Access Compliance Report Public Rights-of-Way (Curb Ramps)

Main Street: STRATTON_WAY Cross Street: 17TH_ST Location: SW

ADA ID: RPRK211007123727 Ramp Type: Type 7 - Directional 2 Initial Pass/Fail: Pass Overall Compliance: No Severity Score: 5

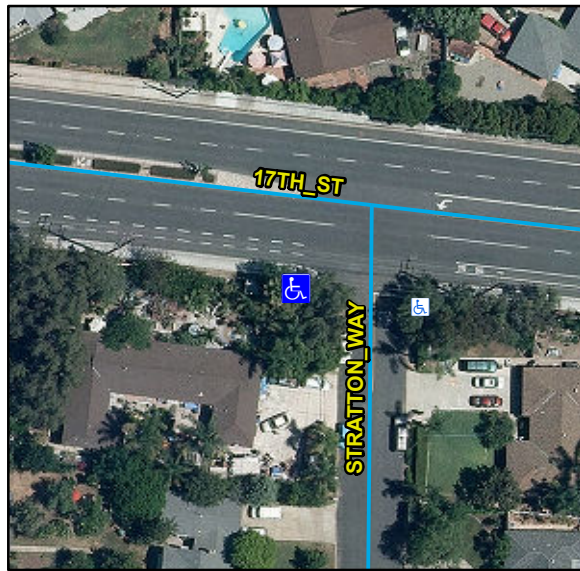
R304.2.2, R304.2.2-Perp, R304.3.2-Para, R304.5.3, R305.2, R302.7, STD 1115

Compliance	Description	Data	Compliance	Description	Data
N/A	Ramp Length (in)	160	Yes	Flare Type LT	
Yes	Ramp Width (in)	50			Curbed2
Yes	Ramp Run Slope (%)	3.8	N/A	Flare Slope LT (%)	N/A
Yes	Ramp Cross Slope (%)	1.9	N/A	Flare Traversable LT	N/A
Yes	Grade Break	Yes	N/A	Flare Type RT	
No	Grade Break Slope (%)	6.2			None
Yes	Grade Break Cross Slope (%)	0.6	N/A	Flare Slope RT (%)	N/A
	Addl Para Ramp Left?	No	N/A	Flare Traversable RT	N/A
	Addl Para Ramp Right?	No	Yes	DWS Provided	Yes
N/A	Landing Present	Yes	Yes	DWS Contrast	Yes
Yes	Landing Length (in)	112	Yes	DWS Length (in)	36
Yes	Landing Width (in)	52	Yes	DWS Full Width	Yes
No	Landing Run Slope (%)	5.5		DWS Offset Type	Multiple
Yes	Landing Cross Slope (%)	0	No	DWS Left Offset (in)	101
N/A	Landing Movement Obstructed?	Yes	Yes	DWS Right Offset (in)	0
	Landing Movement Type	SS			
N/A	Landing Shared	No			
N/A	Marked Crosswalk 1	No	N/A	Clear Space	N/A
	Crossing 1 Direction	E	N/A	Clear Space To Crosswalk (in)	N/A

Marked Crosswalk 1 Width (in)	N/A			
N/A	Ramp Inside Crosswalk 1	N/A			
	Crossing 1 Slope (%)	0.1			
	Crossing 1 Cross Slope (%)	4.2			
No	Gutter Ponding	Yes	No	Curb Slope	8.7
Yes	Gutter Lip Height (in)	0		Road Run Slope (%)	N/A
Yes	Gutter Run Slope (%)	1		Road Cross Slope (%)	N/A
No	Gutter Cross Slope (%)	6.2		Parallel Ramp Side	Left
Yes	Overall Surface Condition	Acceptable	Yes	Perp Joint Present	Yes
	Cross Gutter Present?	No		Spandrel Present?	No
	Replace Cross Gutter?	N/A		Replace Spandrel?	N/A

Remove & Replace Entire Ramp. Remove & Replace Gutter.
